ADDENDUM NO. 2

Reference: Building Consolidation – Utah State Hospital
Department of Human Services – Provo, Utah
DFCM Project No. 11065420

Subject: **Addendum No. 2**

FTG &FDTN PLAN - AREA D (S101D PARTIAL)

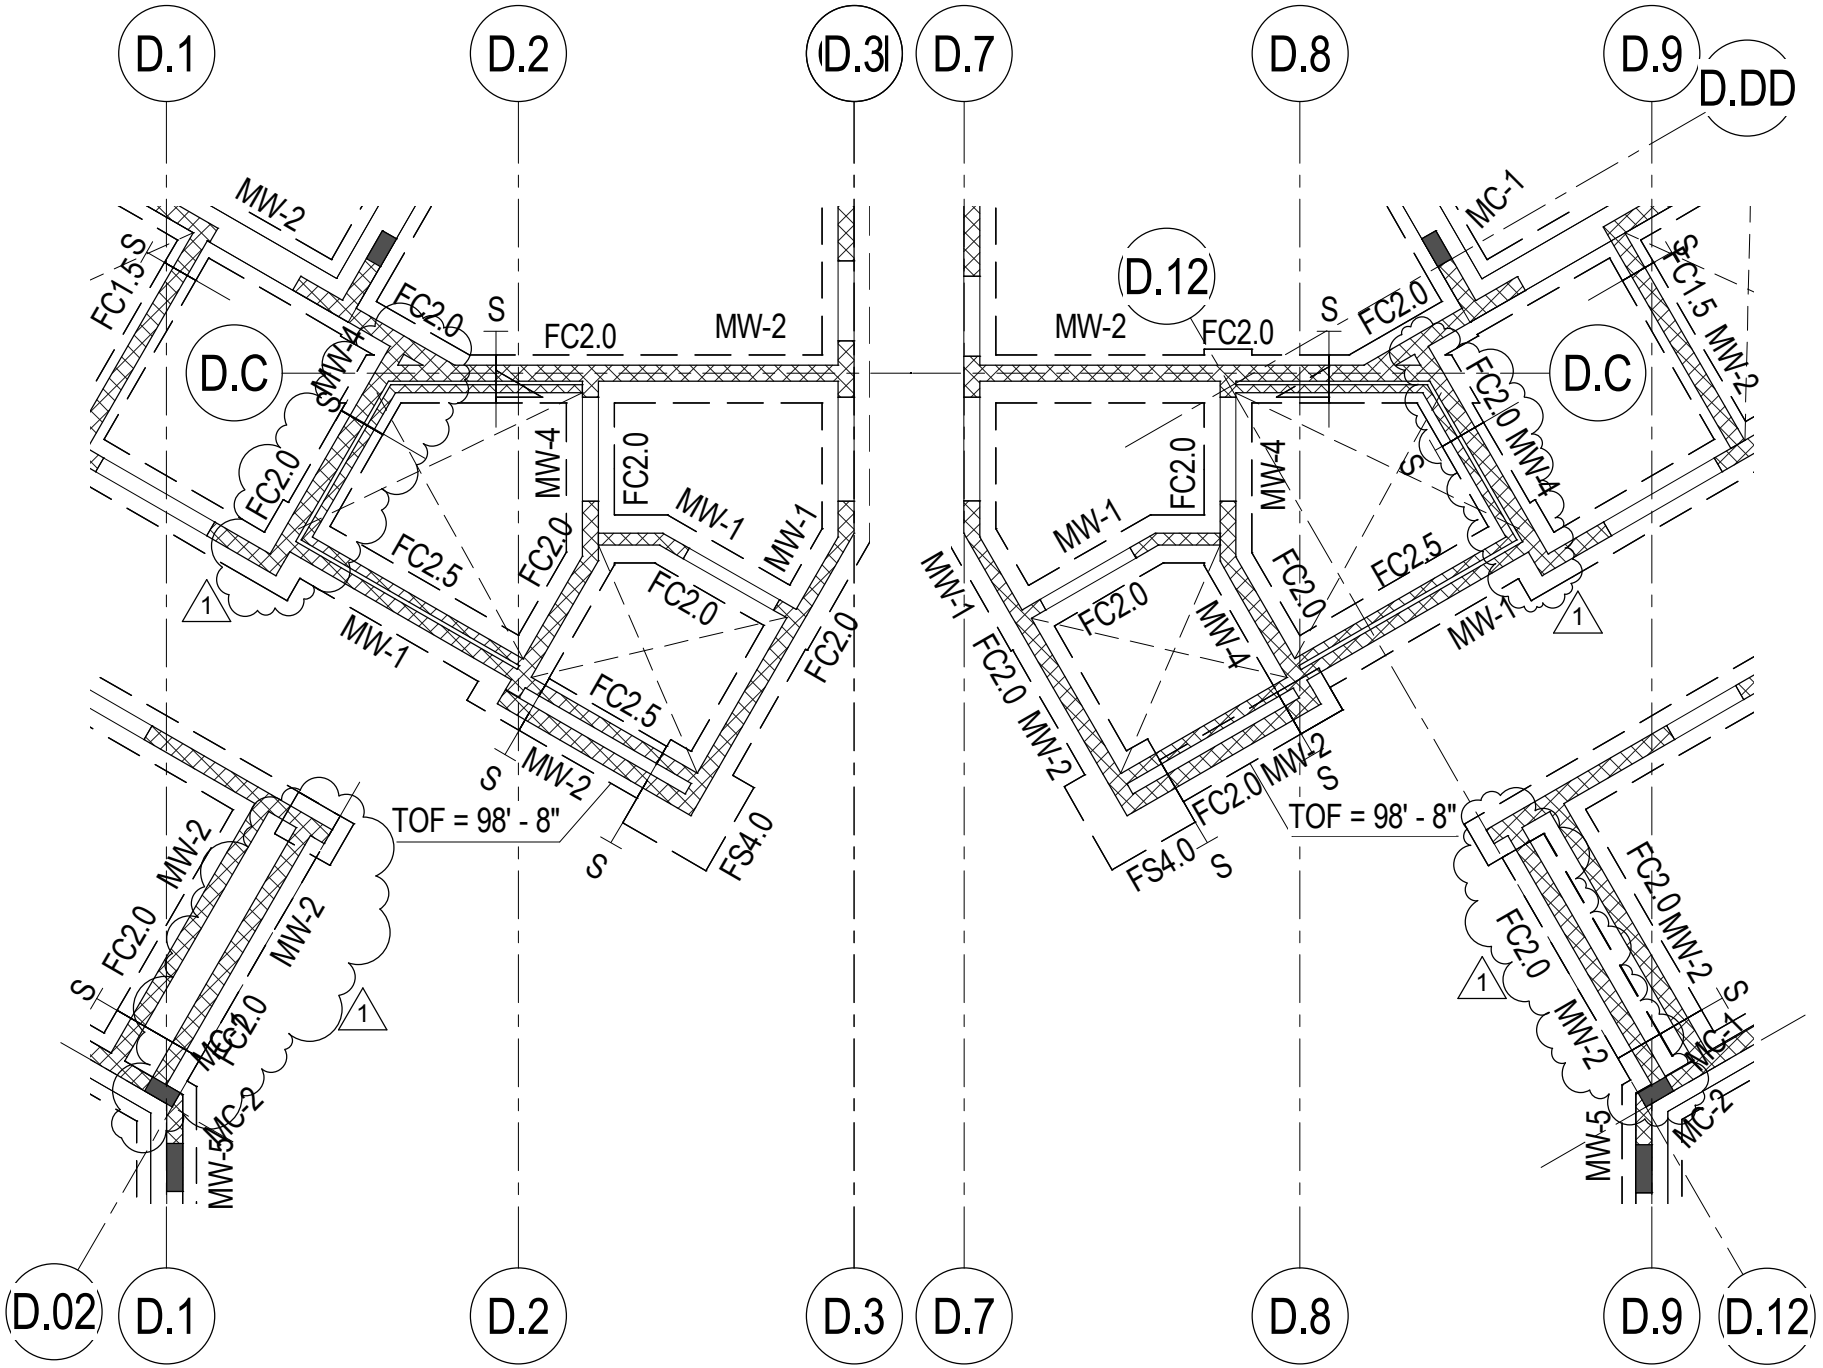
SHEET S101D
1. Revised masonry columns for openings and wall positions per SSD1-5 and SSD1-6.

1 FTG & FDTN PLAN - AREA E (S101E PARTIAL)

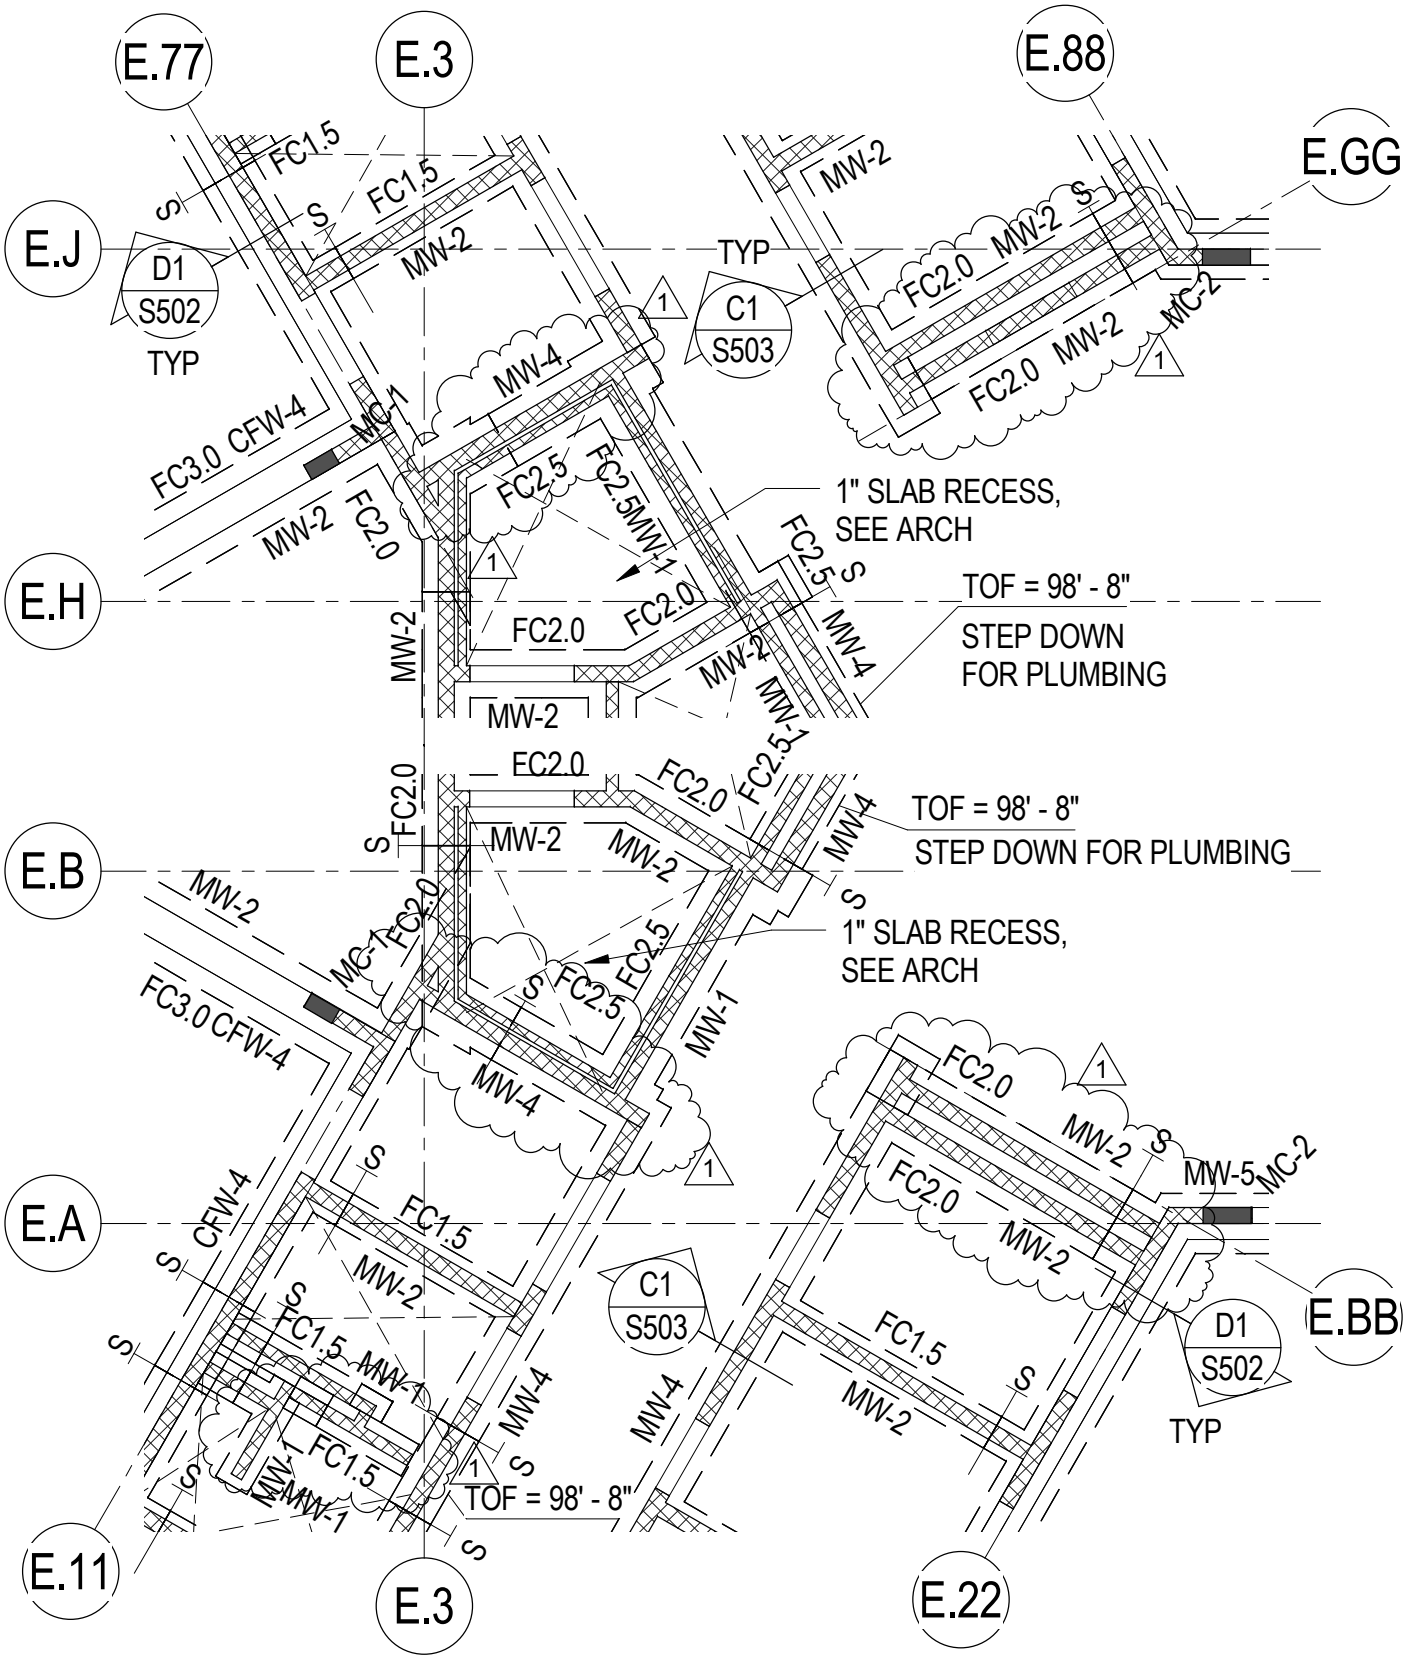
SHEET S101E
1. Revised masonry columns for openings and wall positions per SSD1-7 and SSD1-8.

A2 S102A — Low Roof Area A

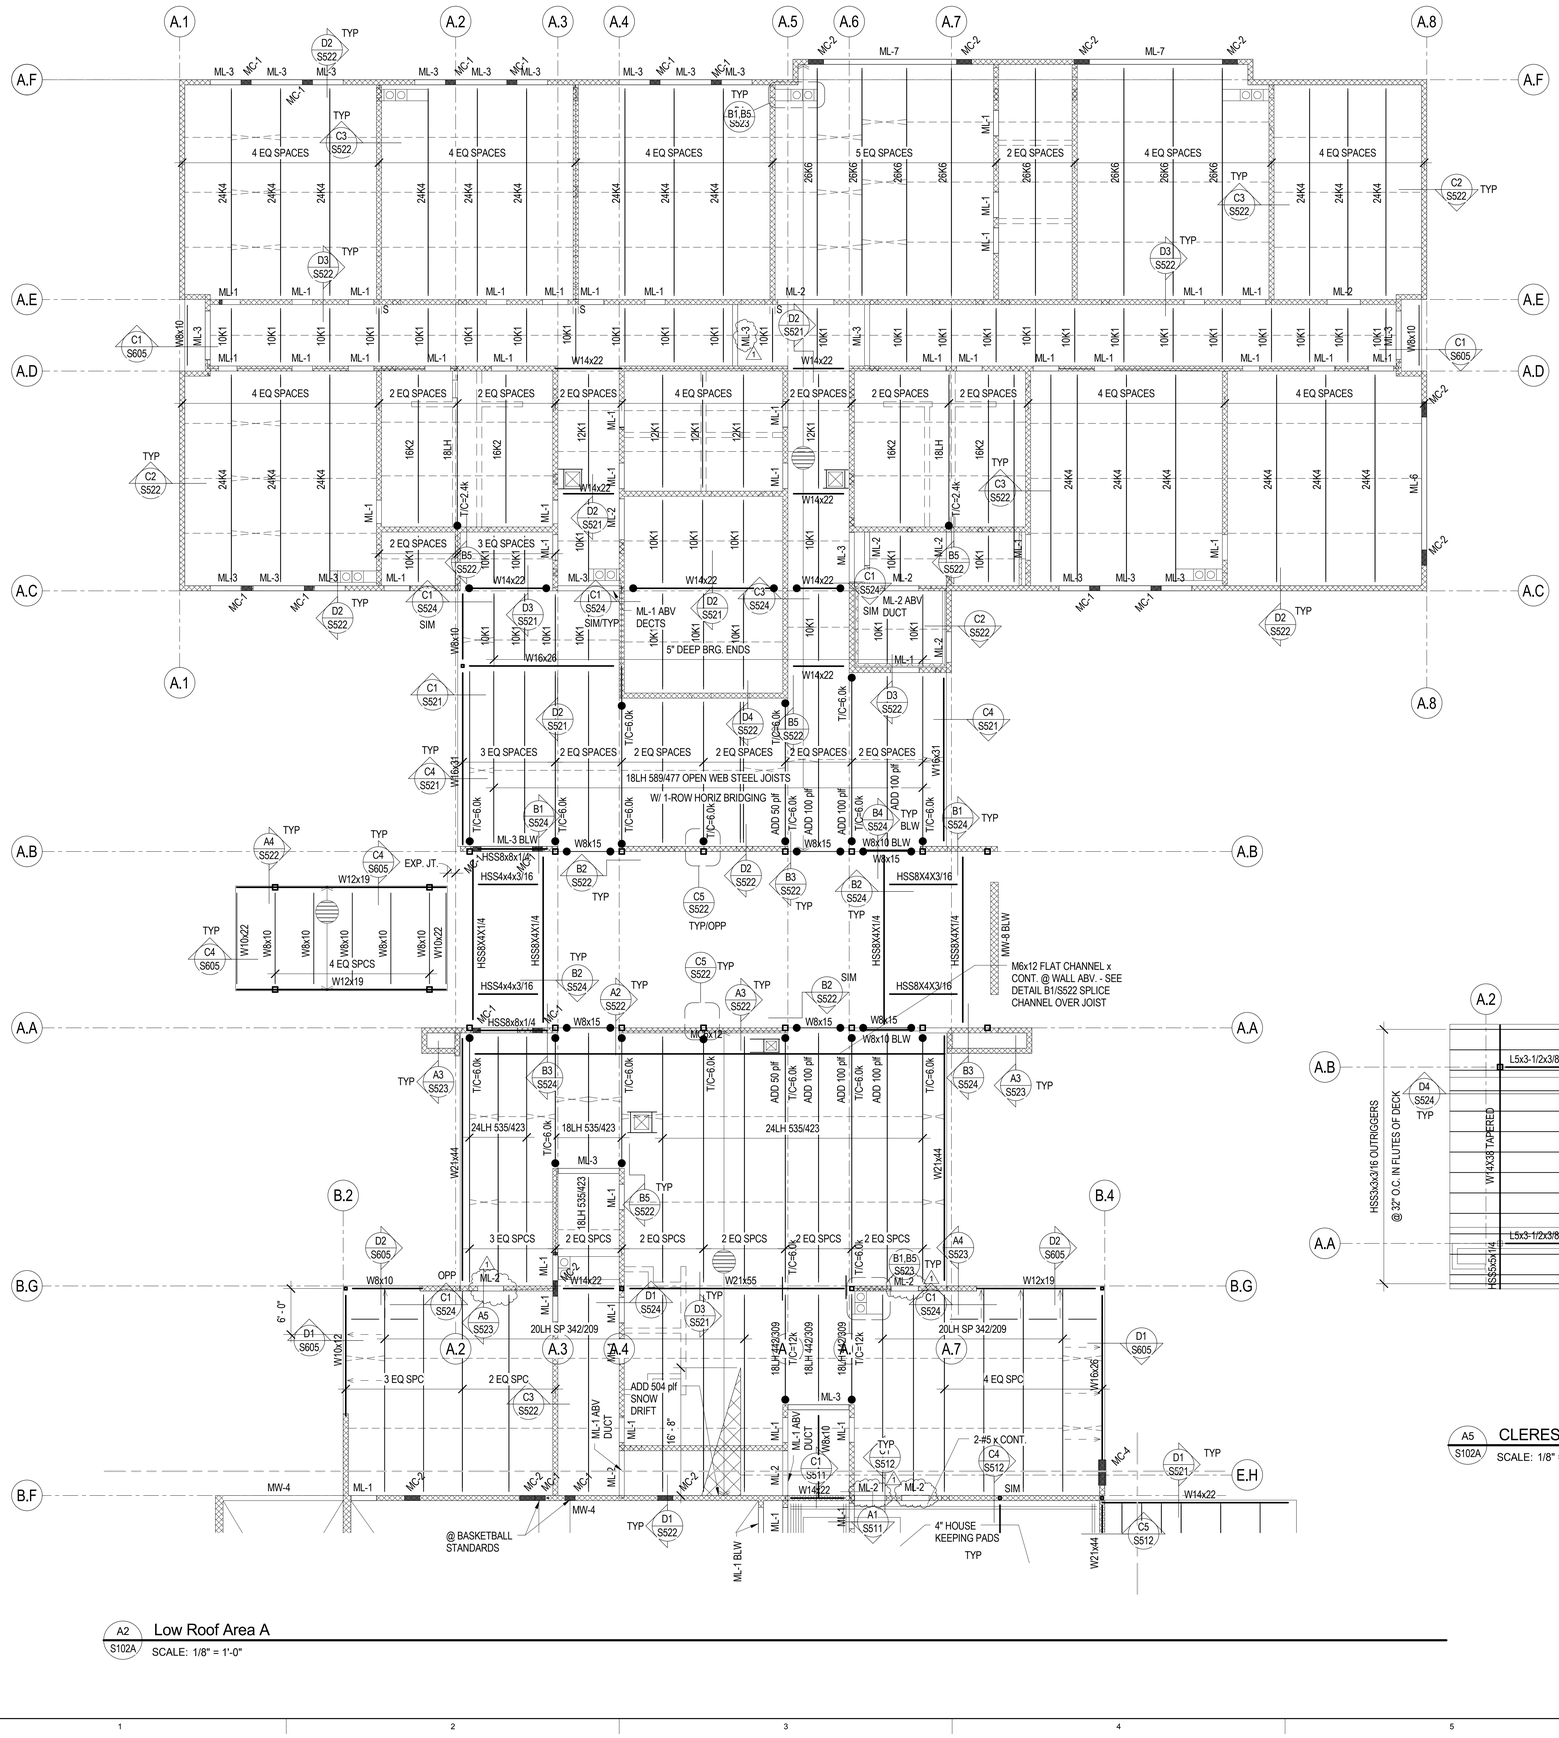
SHEET S102A- See attached sheet, reissued with mechanical information removed.
1. Added lintels for mechanical openings on Grid B.G and B.F (clouded).

A3 / S102B Low Roof Area B

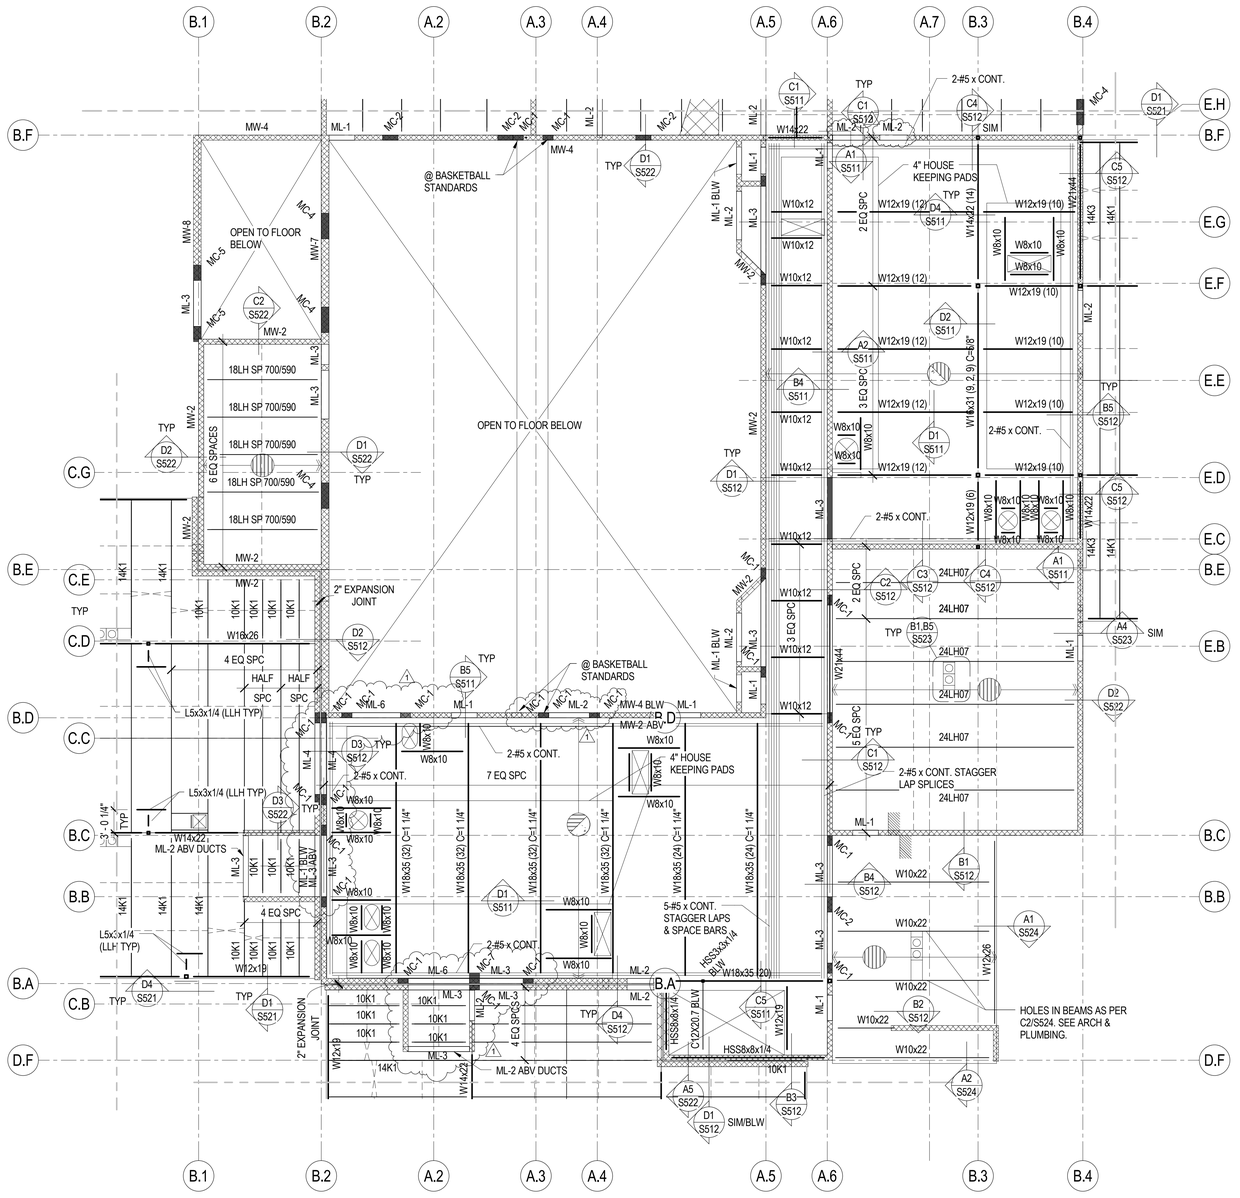
SHEET S102B- See attached sheet, reissued with mechanical information removed.
1. Revised lintels and masonry columns on Grids B.D, B.A, and B.2 (clouded).

B3 TYP SUITE MED 4

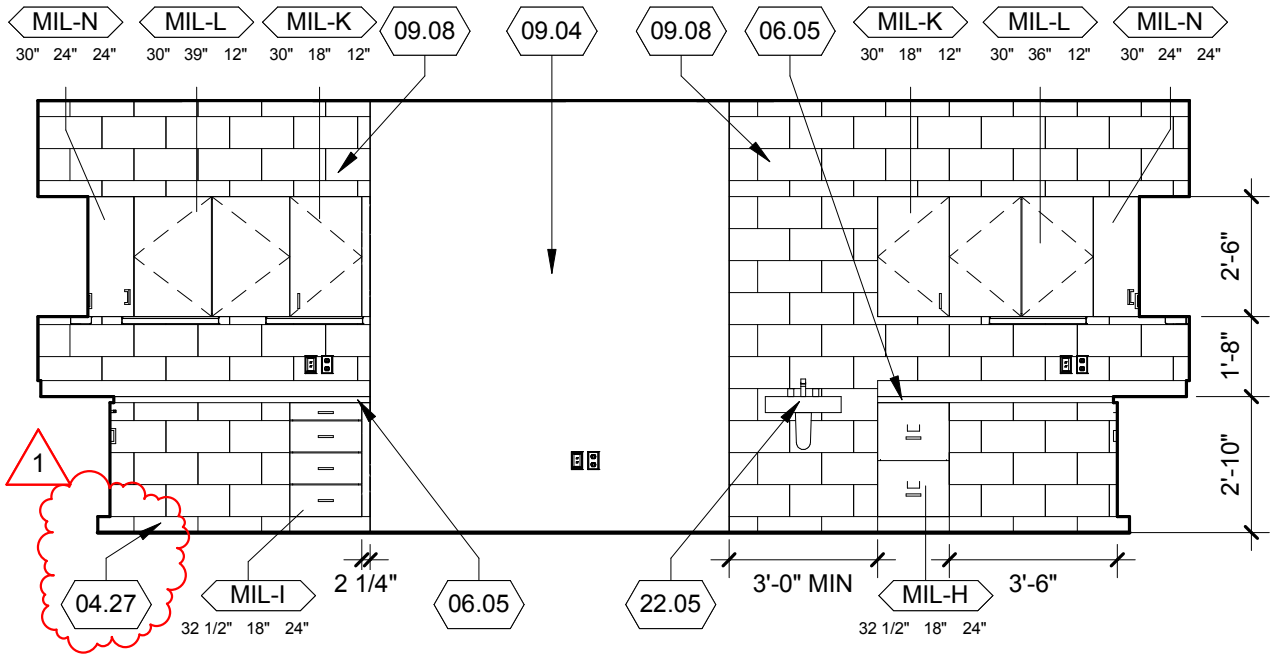
Sheet A415
- Elevation B3 had keynote 4.27 added. See ASD-004

E3 TEACHER WORK S

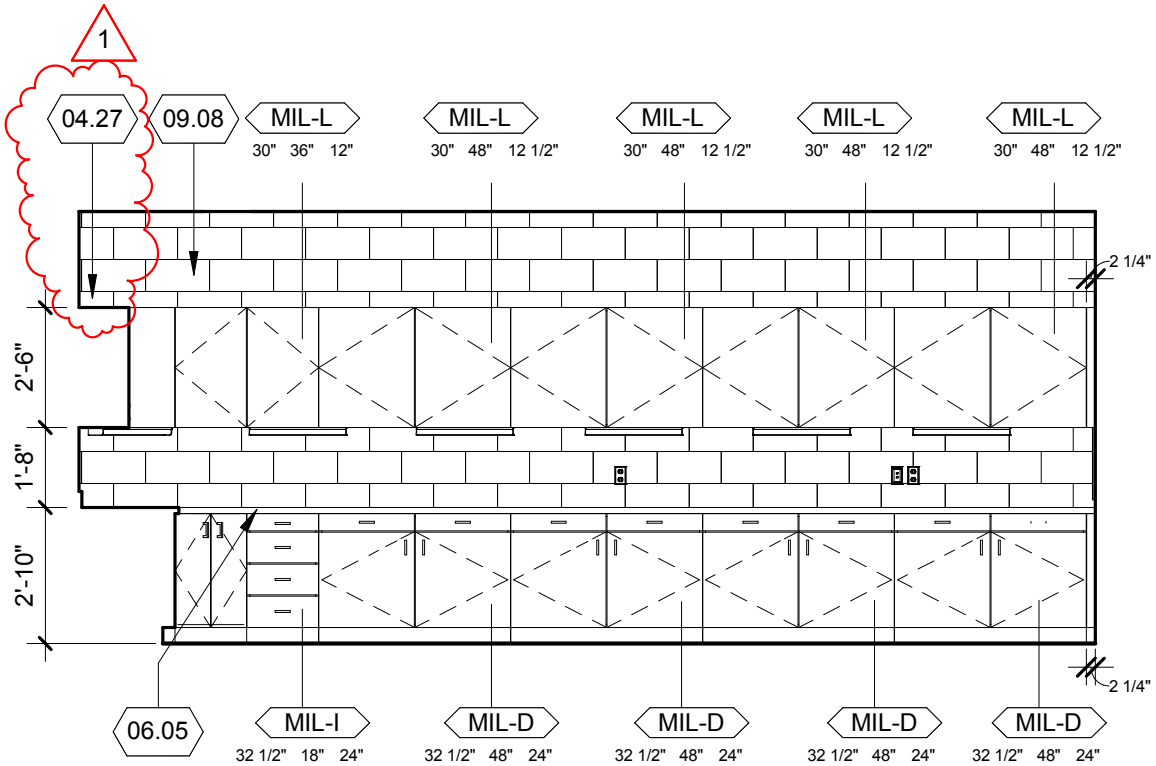
Sheet A418
- Elevation E3 had keynote 4.27 added. See ASD-005
